Report to Development Permit Panel

File: DP 11-575759

Re: Application by Oris Development (Kawaki) Corp. for a Development Permit at

6160 London Road (formerly 6160 London Road and 13100, 13120, 13140, 13160

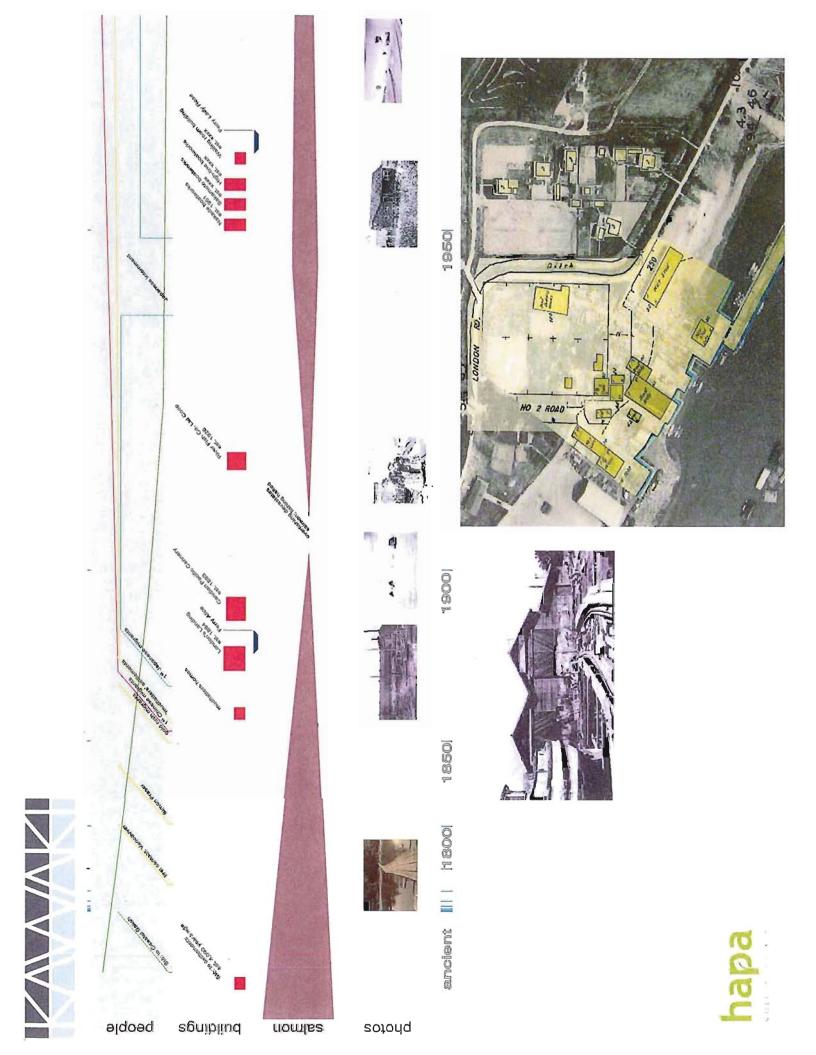
8. consider integrating the restaurant façade into the waterfront edge;

Design development to the south façade of the restaurant has provided a finer grain of architectural detail and improved its relationship/transition to the more natural environment of the waterfront park to the south.
